Addition of Quantization Noise to COM

Additional Material for Comments Against Draft 2.0

Hossein Shakiba

July 09, 2025

Figure 178A-7—Sources of noise considered in calculation of COM

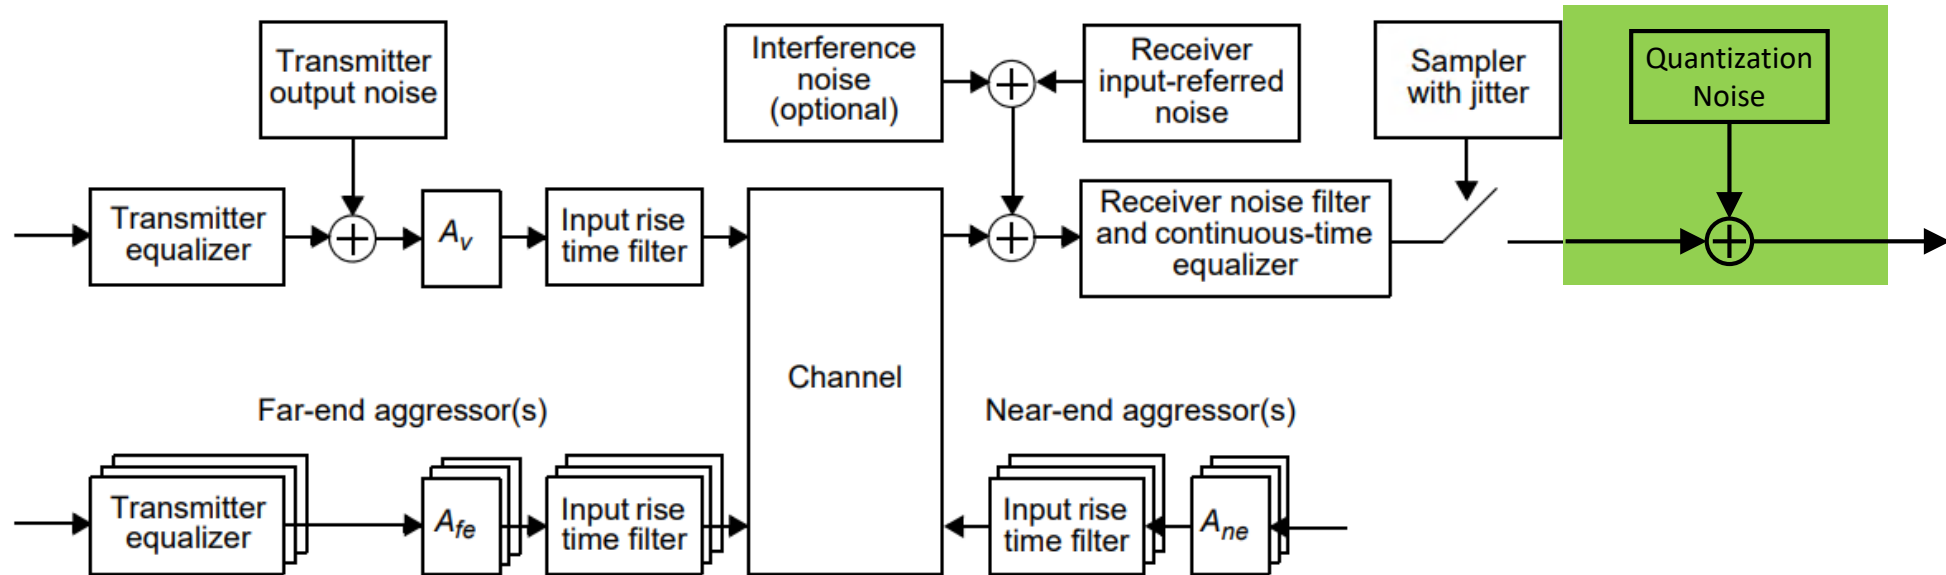
- Comment row #7:
 - ❖ Page 774, Section 178A.1.7, Figure 178A-7
 - ❖ Add quantization noise to the figure

Figure 178A-9—Receiver discrete-time equalizer

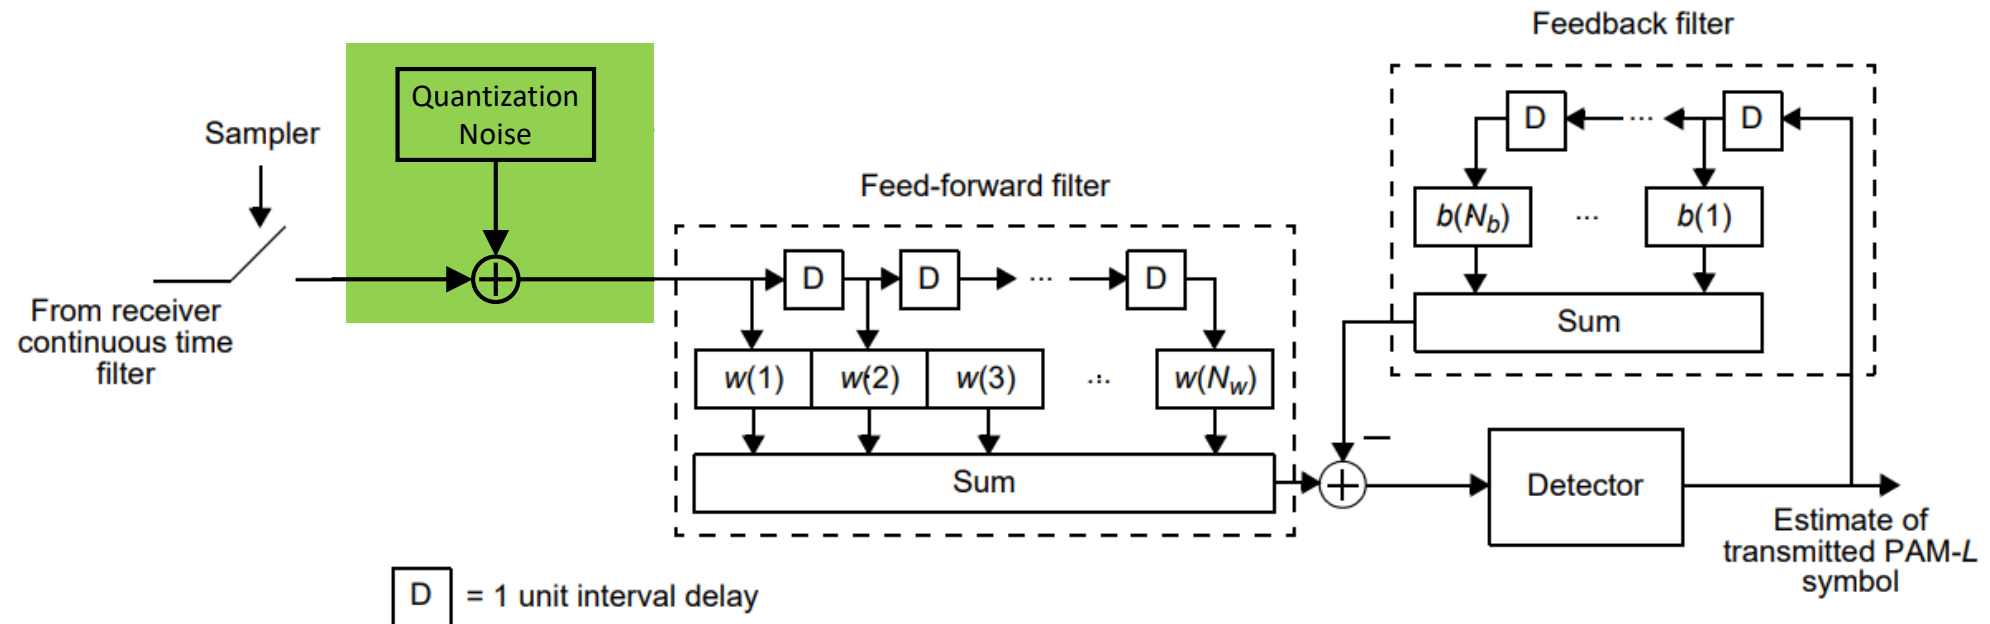
- Comment row #13:
 - ❖ Page 778, Section 178A.1.8.1, Figure 178A-9
 - ❖ Add quantization noise after sampler

Figure 178A-10—Receiver discrete-time equalizer with MLSD

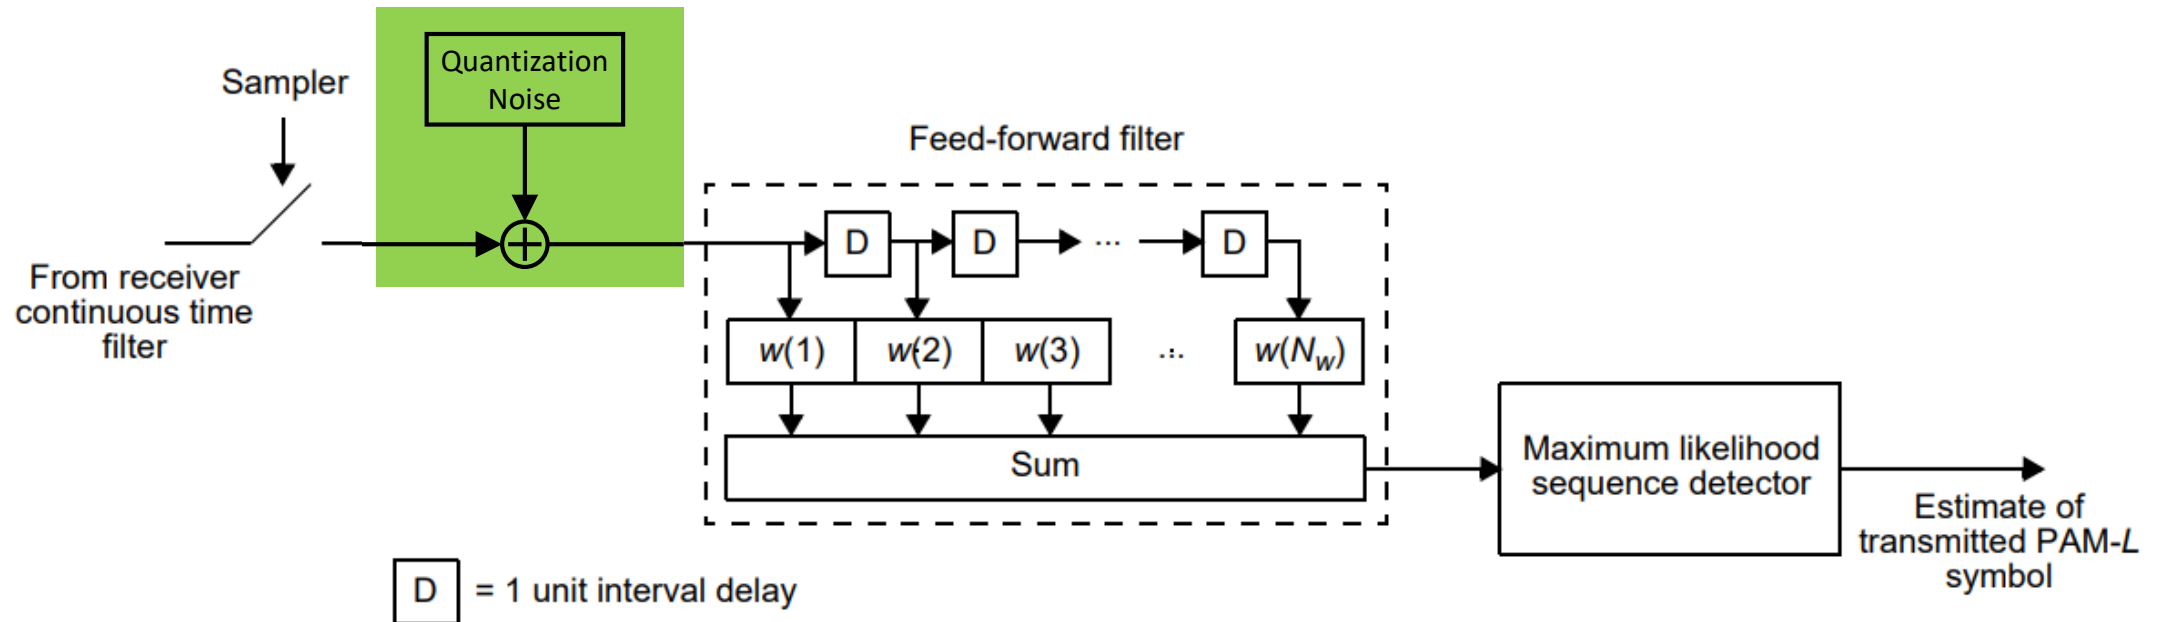
- Comment row #16:
 - ❖ Page 783, Section 178A.1.10, Figure 178A-10
 - ❖ Add quantization noise after sampler
